Rezoning Transportation Analysis

Petition Number: #2022-162

Date	Description
09-29-22	First Review (PDM)

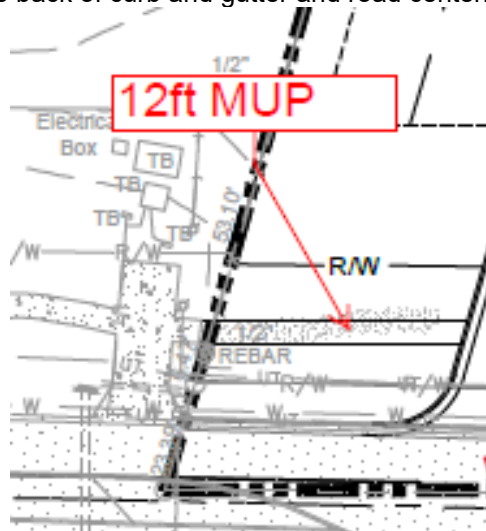
- a. **Weddington Road:** The future location of the back of curb and gutter is located 30-feet from the centerline of the roadway.

Label and dimension the curb and gutter from the centerline for each road on the site plan.
